PLAN FOR PROPOSED BUILDING ON PLOT NO. 64, RB. II.

KARACHI MUNICIPALITY.

REFERENCE No. B. S. P. 283 OF 1932

Re Building ~~XXXX~~ on plot No. 64, R.B. 11, Rambaugh.

PLAN FOR PROPOSED

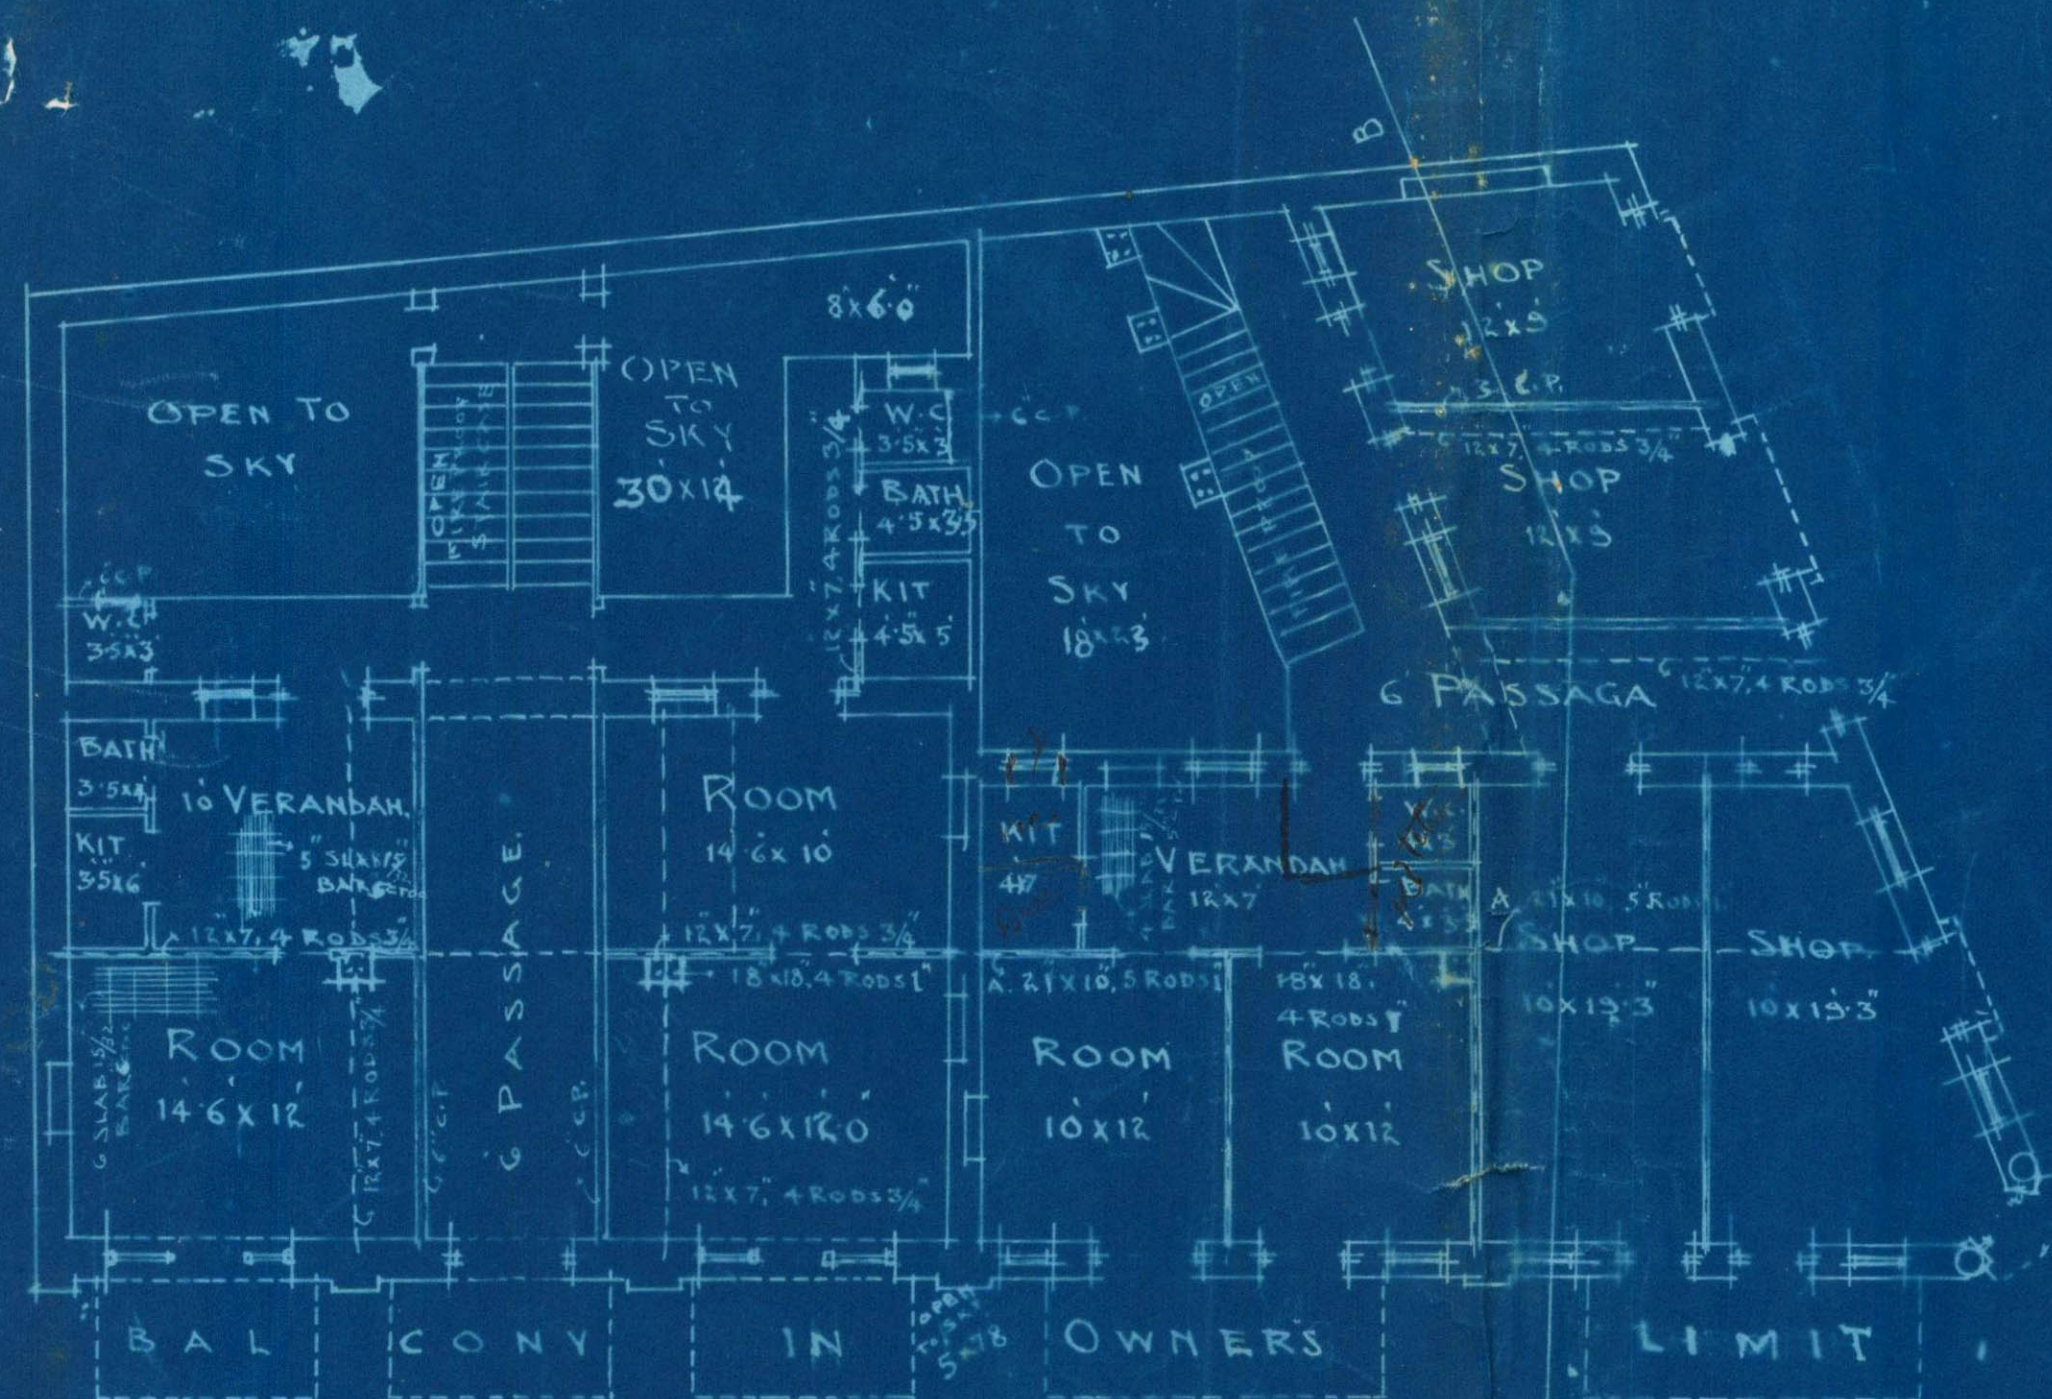
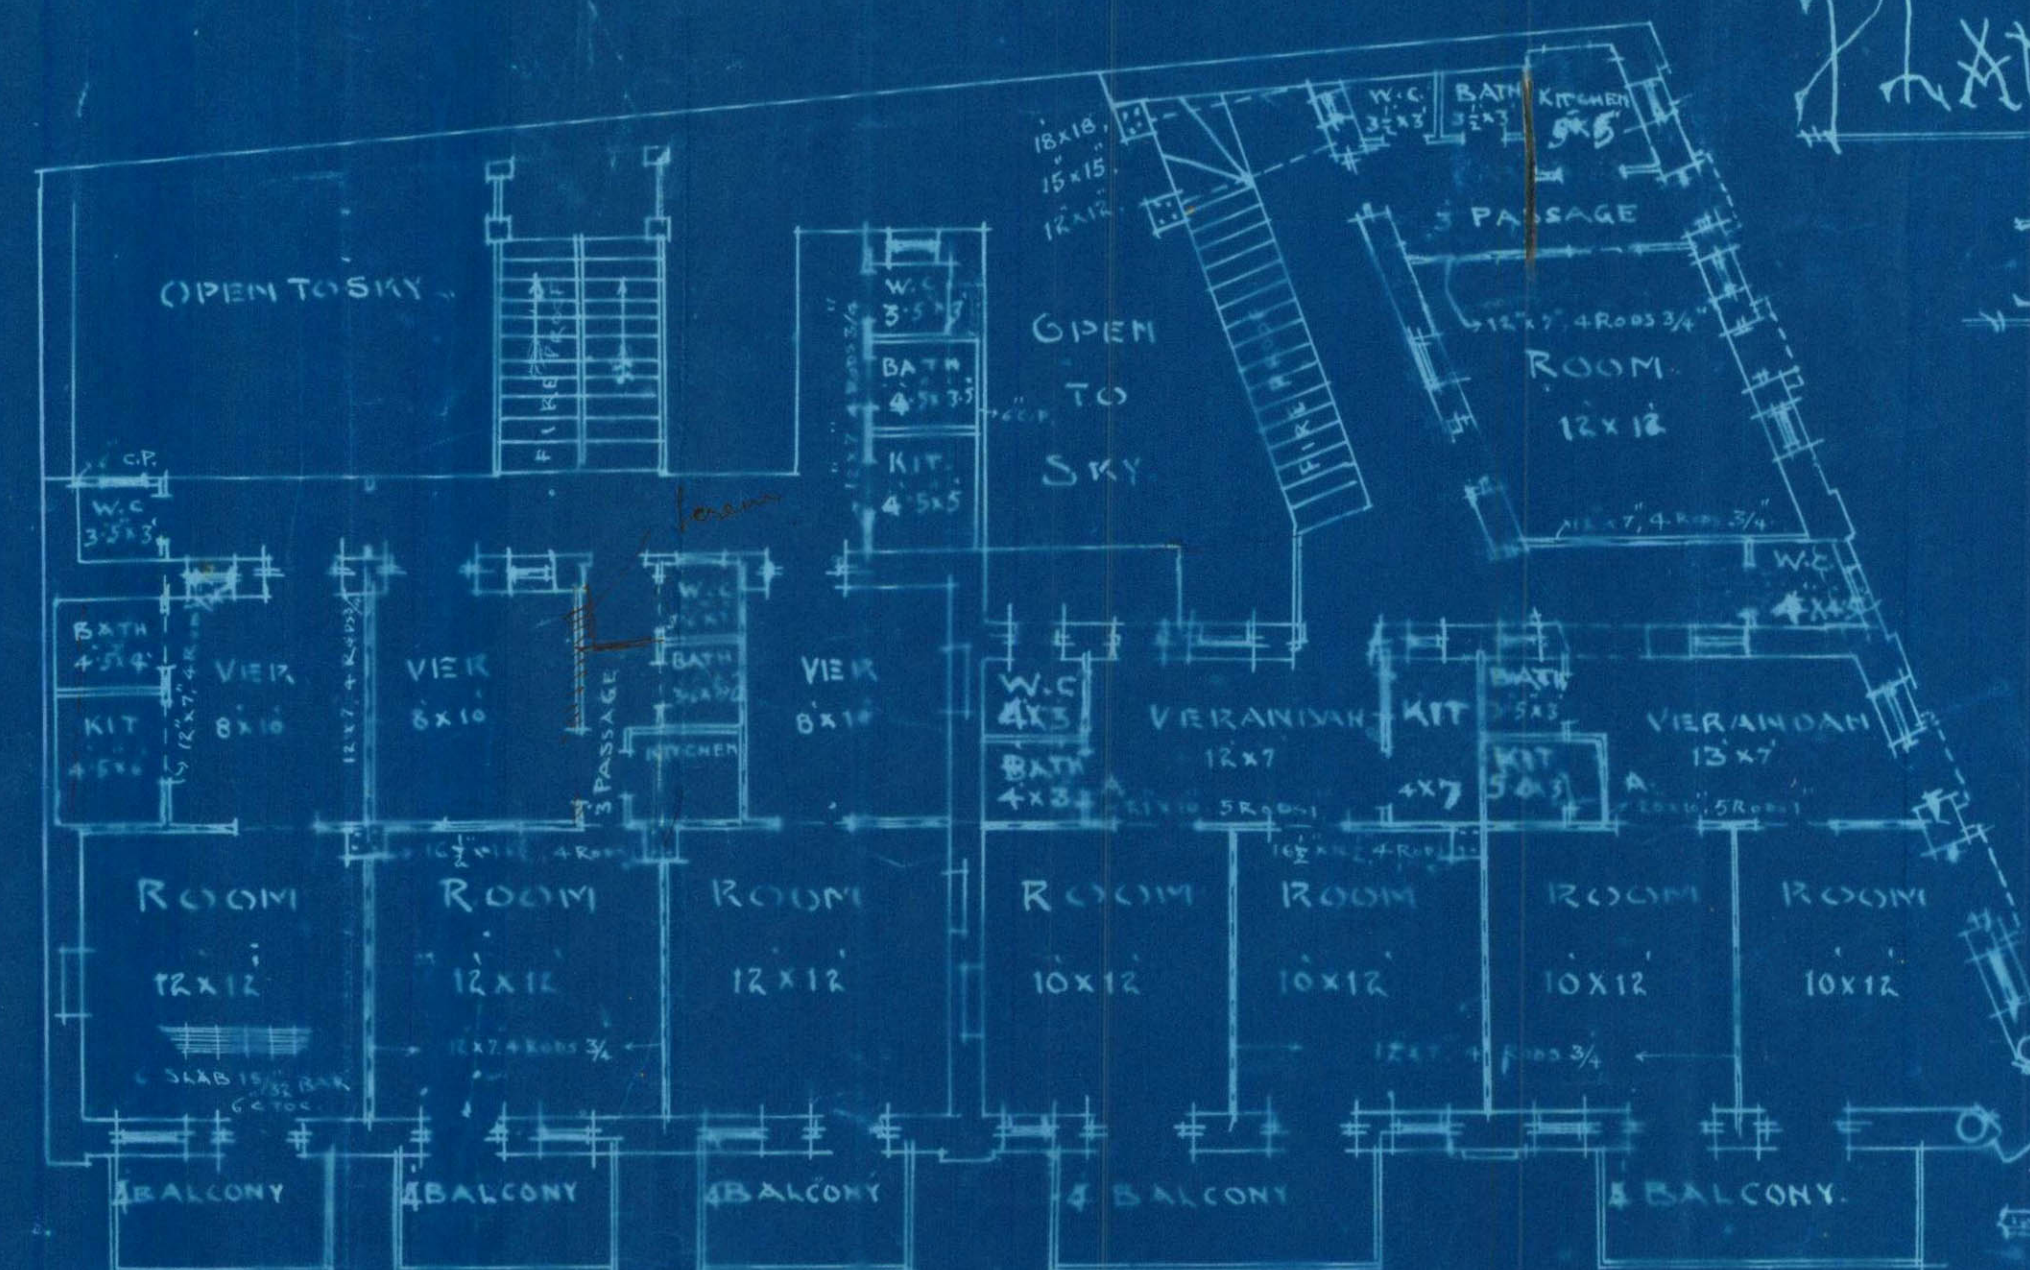
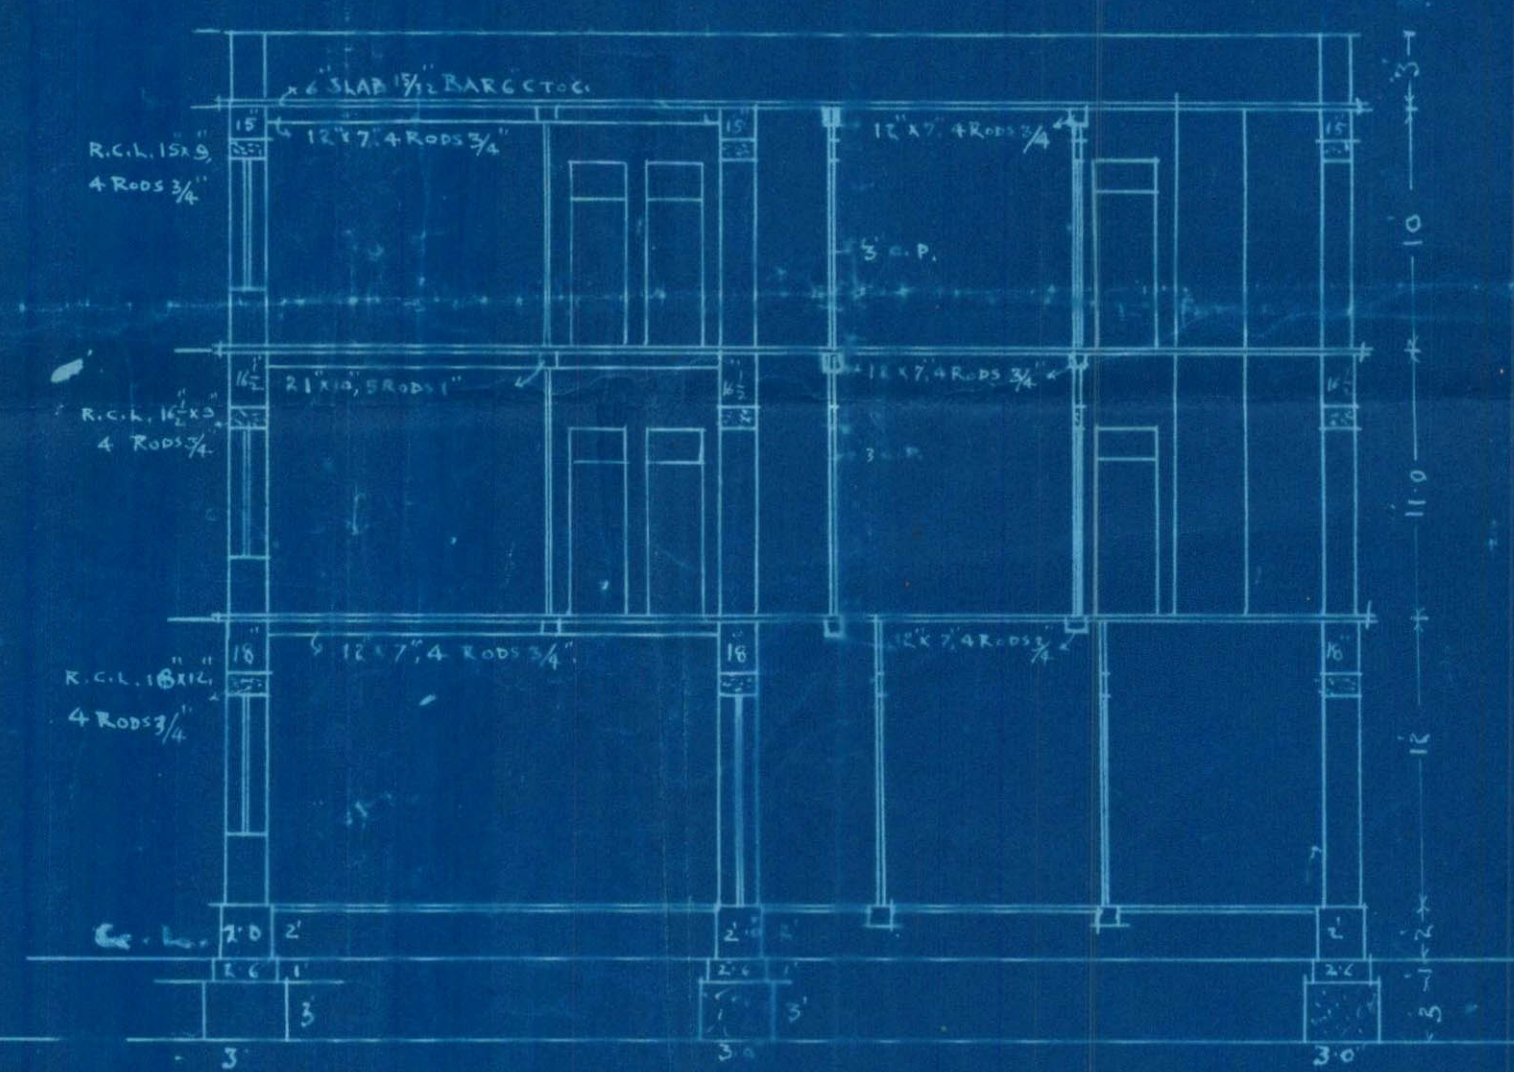
Plan may be approved as the same
has been amended as desired.

c
1. call the architect in
office and issue
notice to stop the work
until the plans are passed.
